PIC18F47J13 Family Silicon Errata and Data Sheet Clarification

The PIC18F47J13 family devices that you have received conform functionally to the current Device Data Sheet (DS39974A), except for the anomalies described in this document.

The following typographic corrections and clarifications are to be noted for the latest version of the device data sheet (DS39974A):

FIGURE 2-3 FREQUENCY vs. ESR PERFORMANCE FOR SUGGESTED VCAP

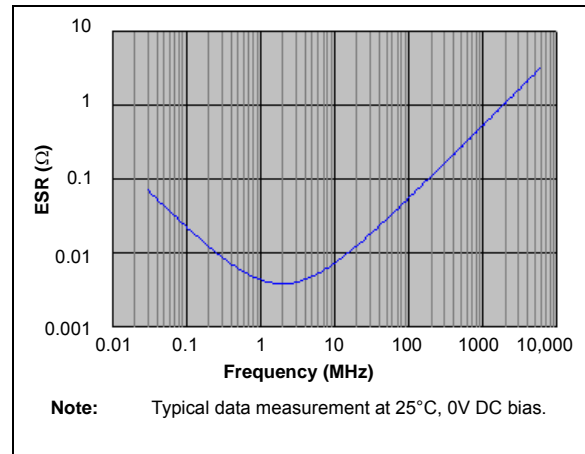
Section “2.4 Voltage Regulator Pins (VCAP/VDDCORE)” has been replaced with a new and more detailed section. The entire text follows:

On “F” devices, a low-ESR ($< 5\Omega$) capacitor is required on the VCAP/VDDCORE pin to stabilize the voltage regulator output voltage. The VCAP/VDDCORE pin must not be connected to VDD and must use a capacitor of 10 μF connected to ground. The type can be ceramic or tantalum. Suitable examples of capacitors are shown in [Table 2-1](#). Capacitors with equivalent specifications can be used.

Designers may use [Figure 2-3](#) to evaluate ESR equivalence of candidate devices.

FIGURE 2-4 DC BIAS VOLTAGE vs. CAPACITANCE CHARACTERISTICS

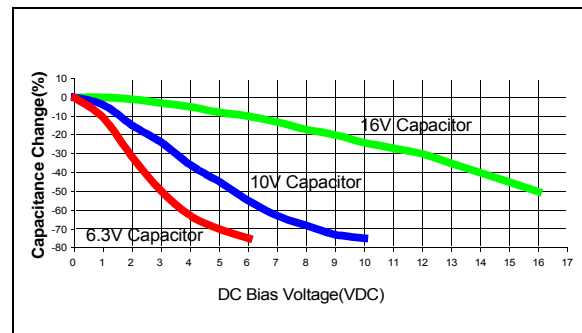
In addition to temperature tolerance, the effective capacitance of large value ceramic capacitors can vary substantially, based on the amount of DC voltage applied to the capacitor. This effect can be very significant, but is often overlooked or is not always documented.

A typical DC bias voltage vs. capacitance graph for 16V, 10V and 6.3V rated capacitors is shown in Figure 2-4.

When selecting a ceramic capacitor to be used with the internal voltage regulator, it is suggested to select a high-voltage rating, so that the operating voltage is a small percentage of the maximum rated capacitor voltage. For example, choose a ceramic capacitor rated at 16V for the 2.5V core voltage. Suggested capacitors are shown in Table 2-1.
